A3.3.41 NP RESPONSE TO NRW REQUEST FOR ILLUSTRATIVE EXAMPLES OF AVIATION LIGHTING EFFECTS

Subject: RE: Y Bryn Wind Farm - Aviation Lighting scheme, VPs and ZTVs NRW:01273097

Y Bryn Wind Farm

Appropriate Noise Limits

Figure – Lines of Sight over NRW Long Term Felling Plan
Example Photowire (VP2 – Maesteg Golf Course)

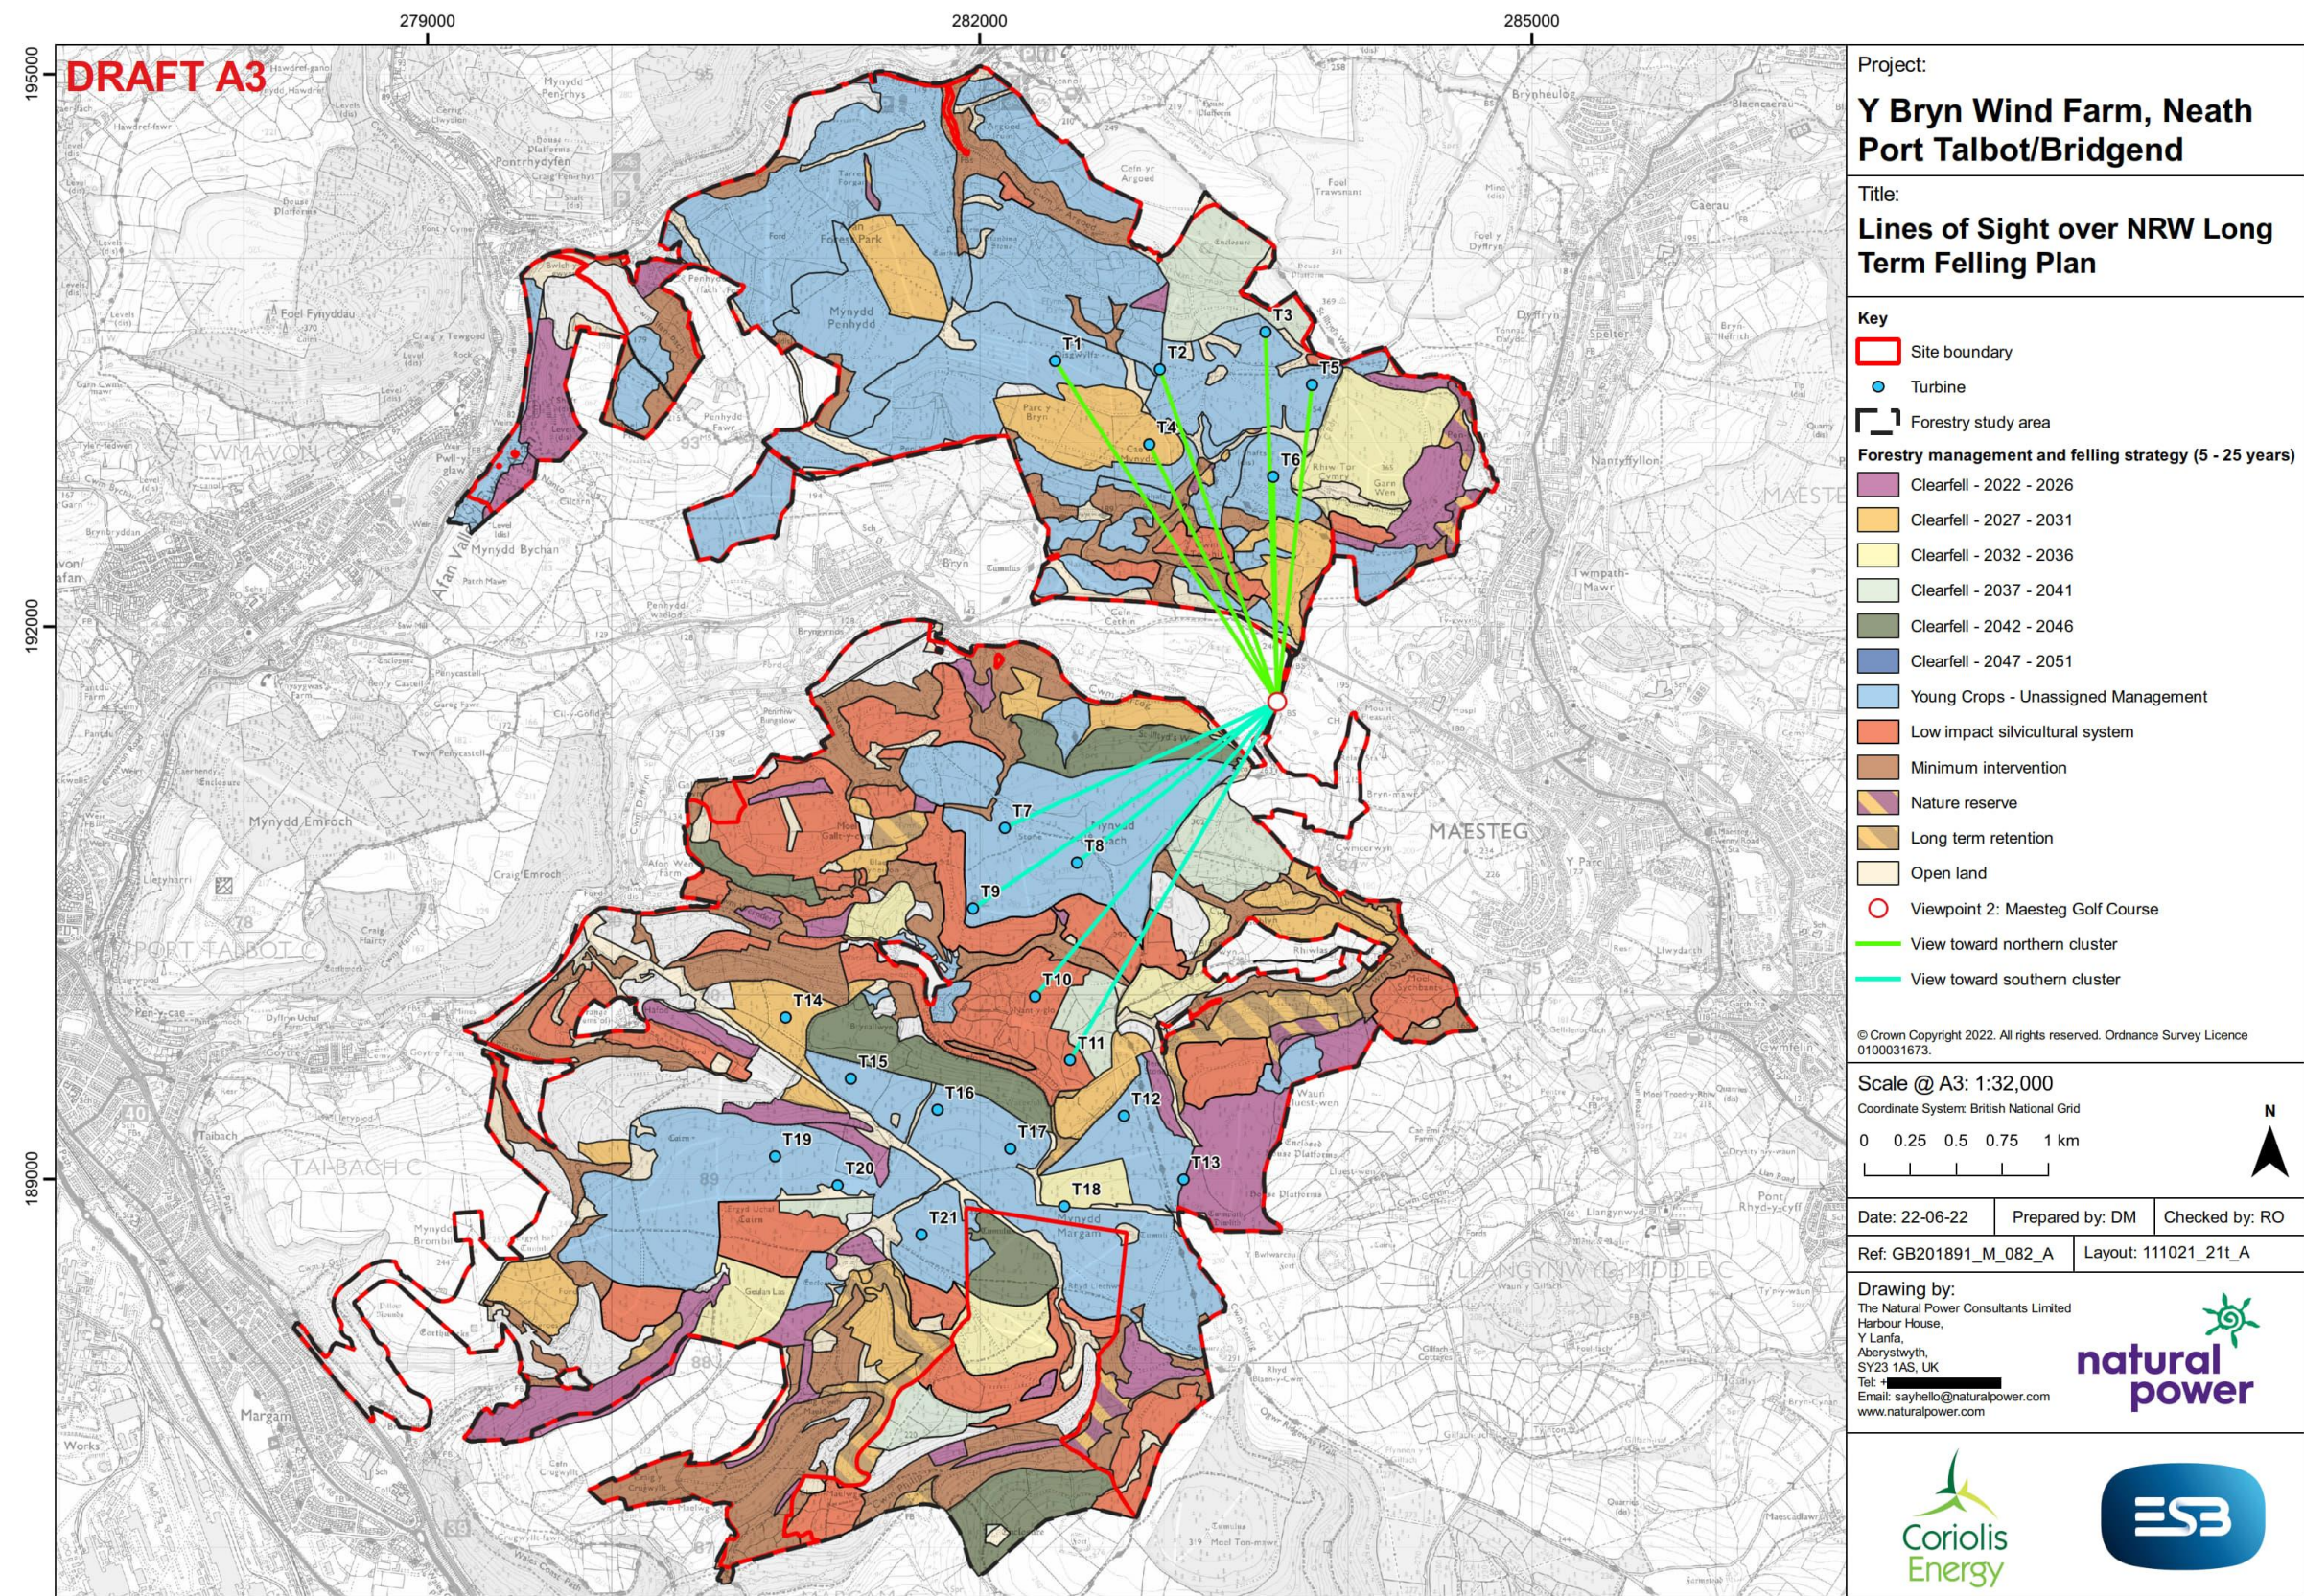
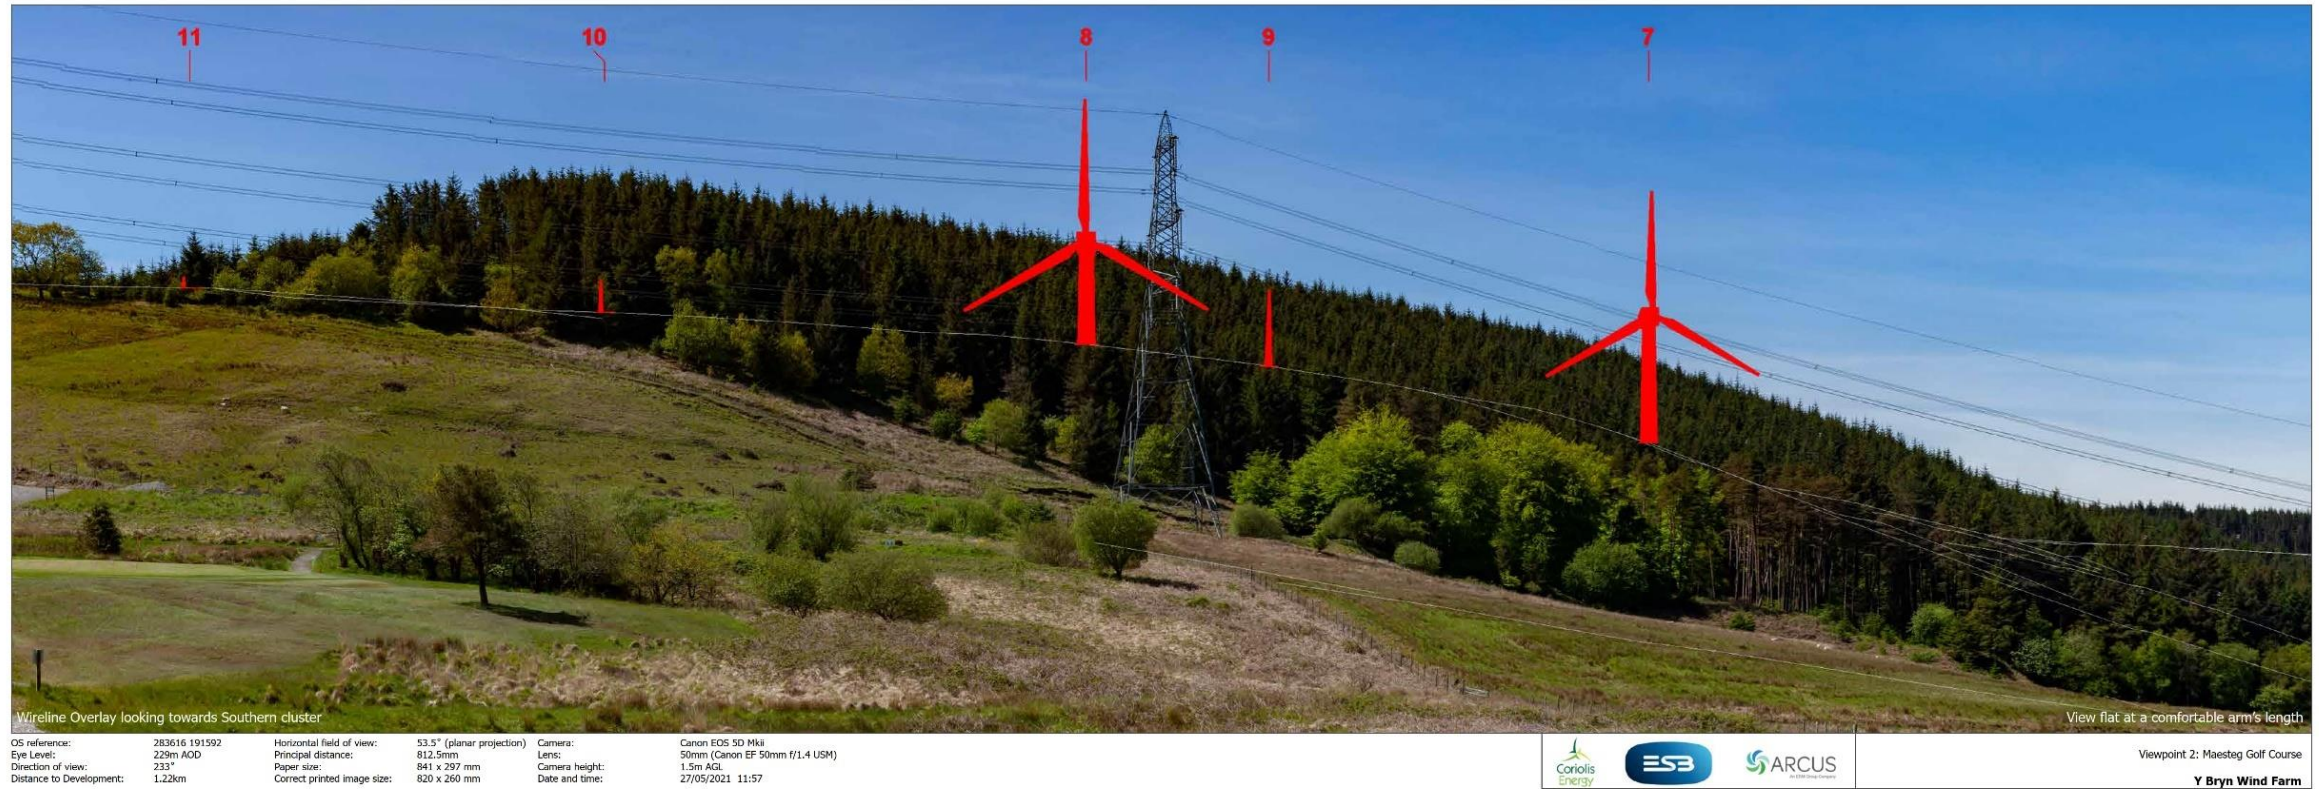
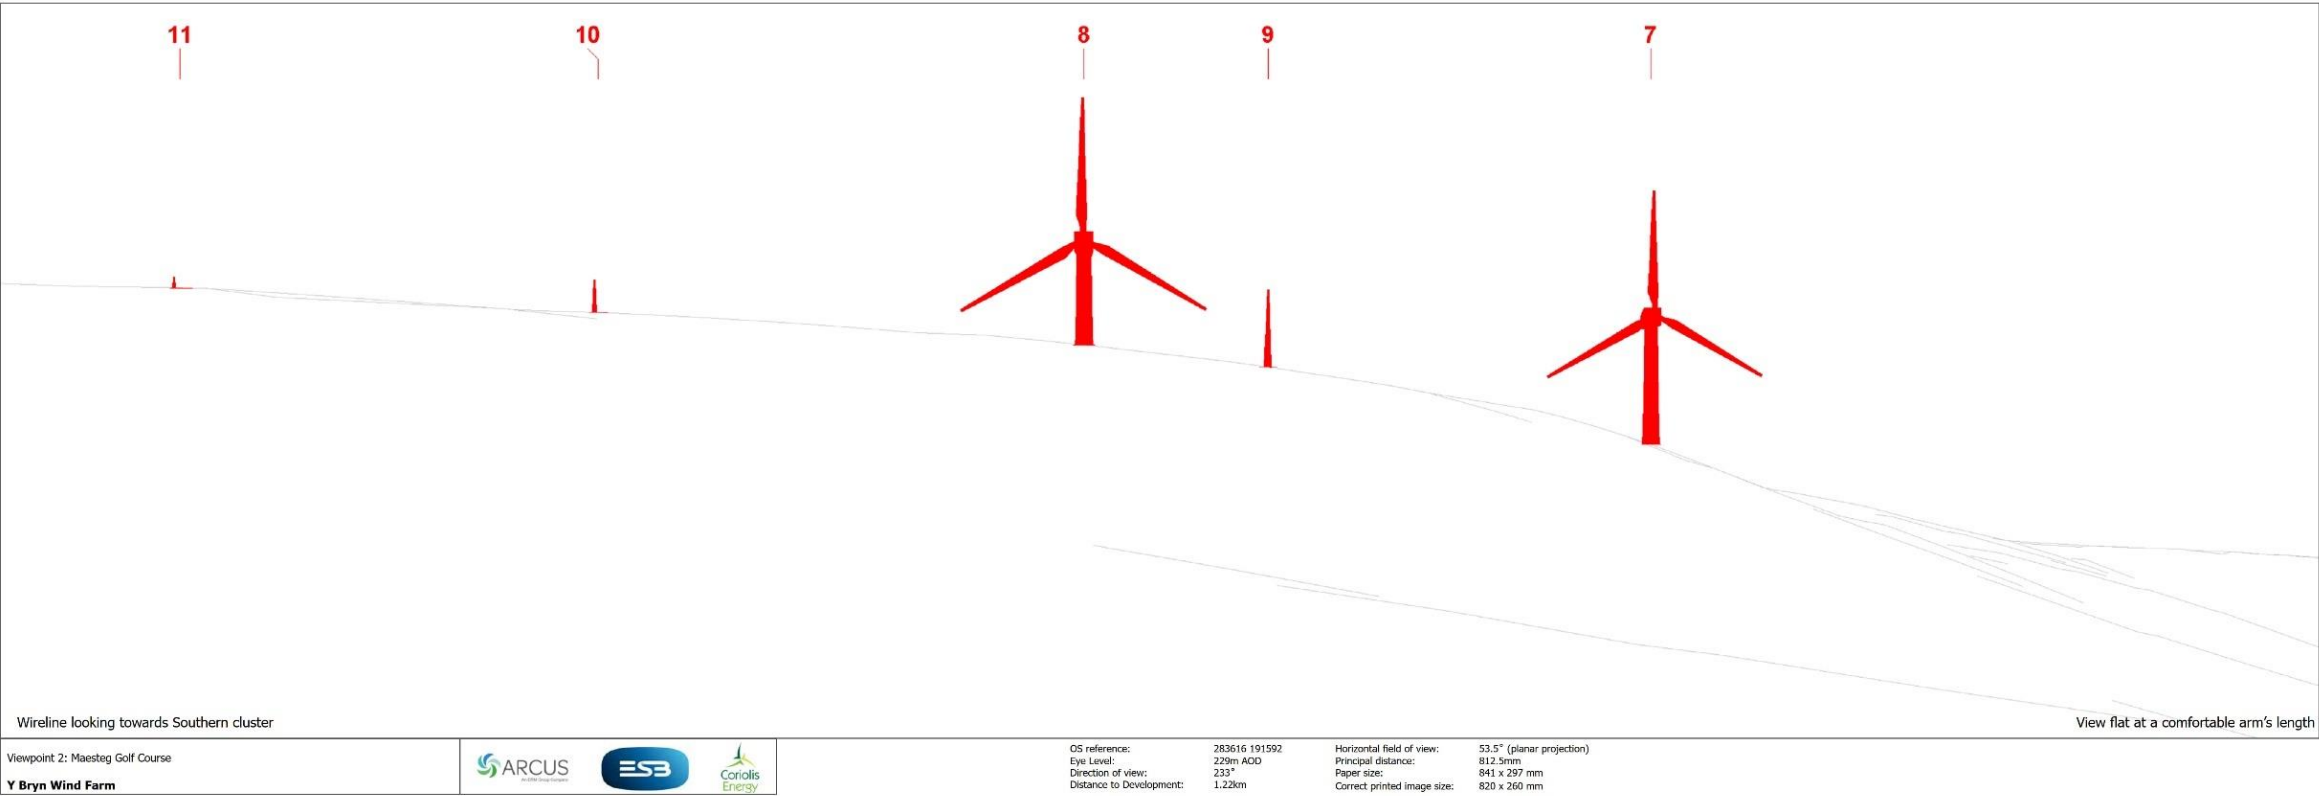
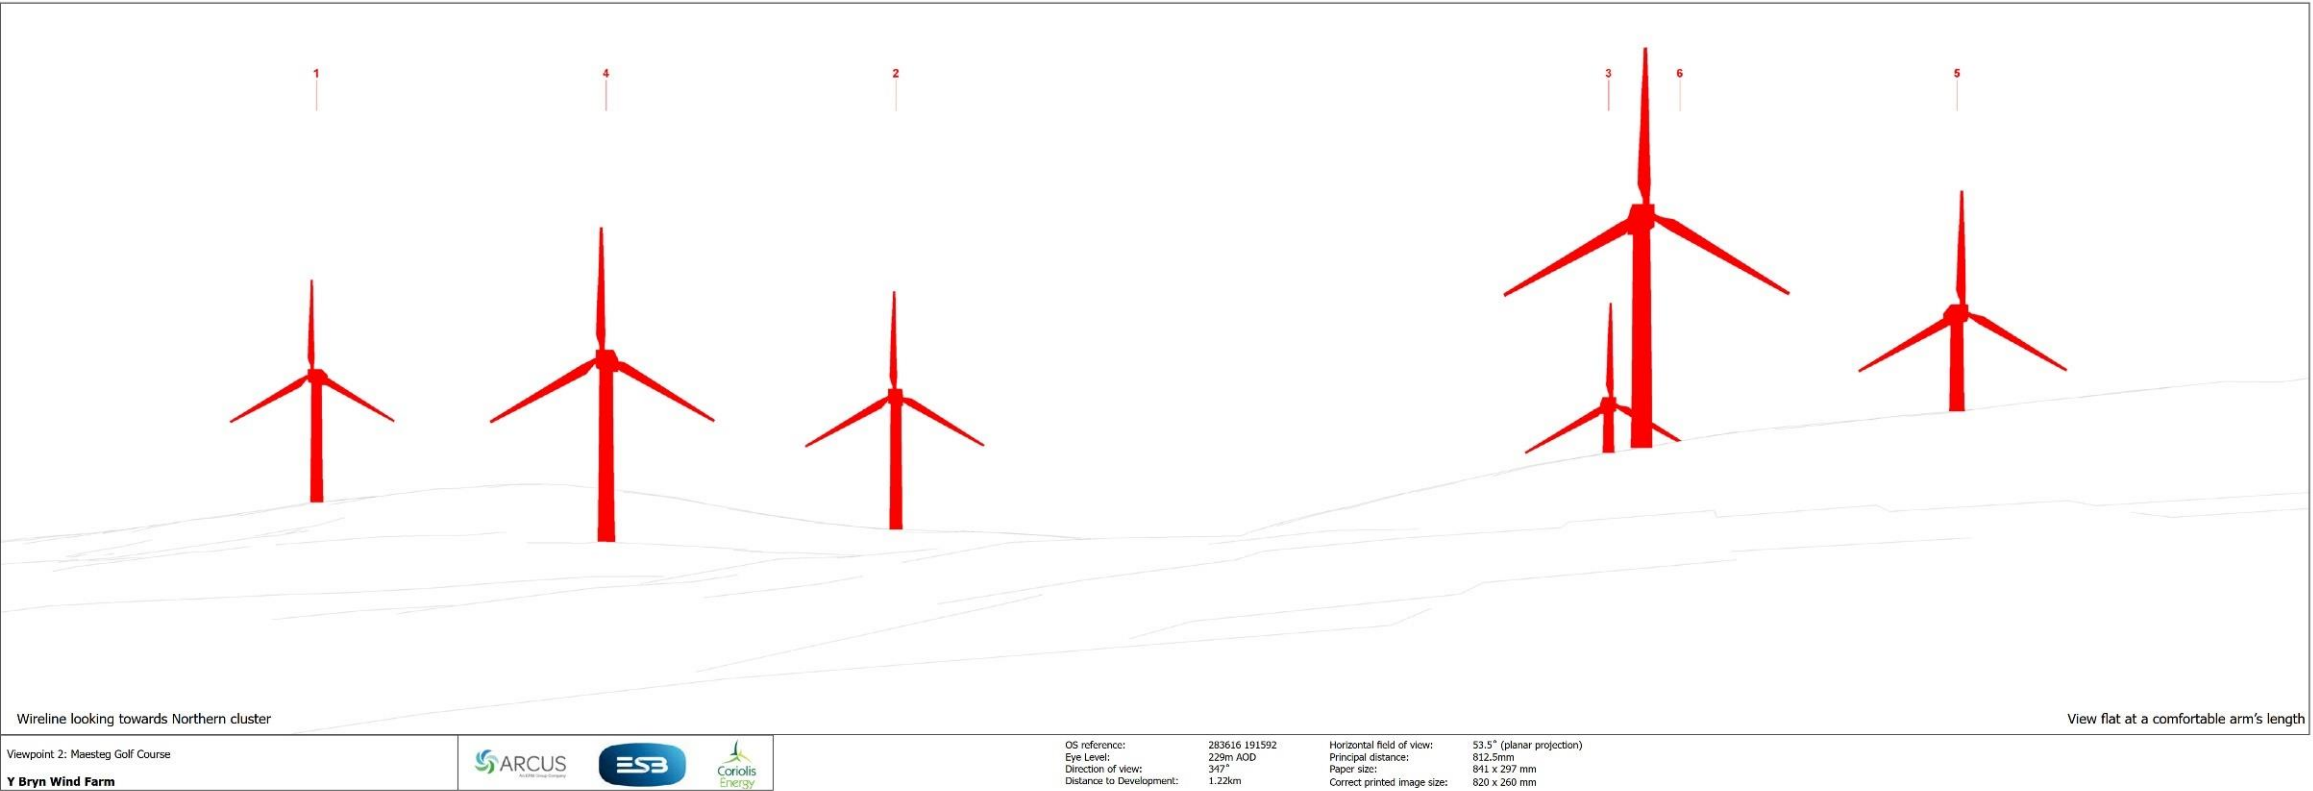
- Identify lines of sight from each viewpoint, extending to the nearest turbines within each view in order to assist in referencing/locating individual forestry coupes that are shown within the attached *Figure – Lines of Sight over NRW Long Term Felling Plan*. This figure shows an example of this approach for VP2 – Maesteg Golf Course.

- Prepare a photowire to illustrate the bare earth view superimposed with the photomontage. These figures indicate the ‘worst case’ scenario i.e. that all forestry coupes would be harvested at the same time, which in reality is not the case. Please note that photomontages cannot be accurately produced to illustrate changes in the view due to the inherent dynamic nature of forestry growth and management with ongoing harvesting and replanting operations. An example Photowire for VP2 – Maesteg Golf Course is enclosed.

There are two areas of forestry currently planned for felling in direct line-of-sight to the nearest turbines, T7 and T8, within the southern section. Both forestry coupes are approximately 400 m from the VP to the south-west. The coupe shaded dark orange colour on Figure – Lines of Sight over NRW Long Term Felling Plan is due to be clear felled between 2027 to 2031 and the coupe shaded dark green between 2042 to 2046. Immediately beyond these forestry coupes, further to the south-west on the Mynydd Bach plateau, is an extensive block of unassigned forestry which was planted between 1980 to 1999. Following felling of the above forestry blocks to the front of the young forestry, which is scheduled to be completed by 2046, the assigned management (shaded light blue) will have an additional 24 years of growth and to have reached a mature height being 47 to 66 years old. This area of forestry, will effectively duplicate the degree of screening currently provided by the coupes due to be harvested from 2027 onwards. The two coupes harvested will, in addition, it is assumed be replanted and will offer further screening from year 2031 onwards. Following the harvesting of forestry in 2042, the blade tips of T9, T10 and T11 should remain screened from view to a degree by the unassigned forestry.

Within the northern section, the forestry coupe located on Caer Mynydd/Parc y Bryn (shaded orange) is due be harvested between 2027 and 2031. Following this, there will potentially be increased visibility towards the lower part of the tower to T4 as well as to T1. However, the unassigned management areas surrounding the forestry coupe (planted 2004 and 2014) will continue to establish and will reimpose a degree of screening that currently exists to T4. However, the forestry coupe titled ‘minimum intervention crops’ and also the coupe of ‘Low impact silvicultural system’ will also contribute to the degree of screening provided to the towers of turbines T4 and also T6. For all other turbines there will be no perceptible change following forestry management during the lifetime of the proposed development from currently planned management.
